**Paddock Wood Town Council**  
**Matter 7 – Highways Infrastructure**

***ISSUE 1 – Strategic and Local Road Networks***

Figure 4: Figure 7: Hotspot Junction Locations – Local Plan Modal Shift Scenario, Local Plan Strategic Transport Assessment – Modelling Appraisal (April 2024)

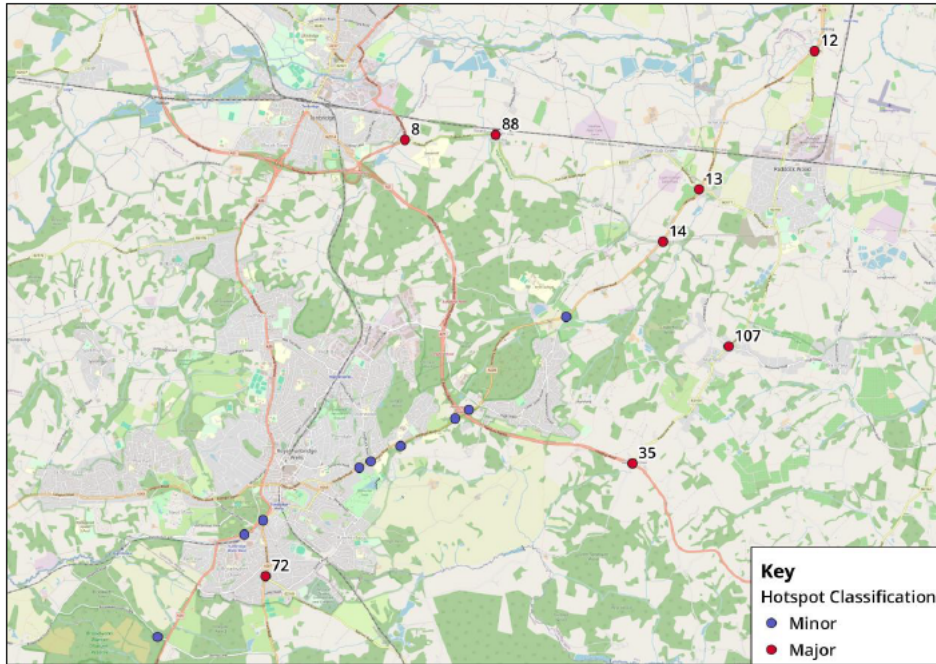
15. All of the Major hotspots are in relation to the Paddock Wood growth apart from the A267/B2169 Birling Road Junction (Reference: 72) in Tunbridge Wells.
16. As the Examination appears to still be considering whether the Colt’s Hill Bypass is required, suitable in terms of environmental impacts and even deliverable, the modelling should surely include a scenario without Colt’s Hill Bypass as it does not appear to in the study.
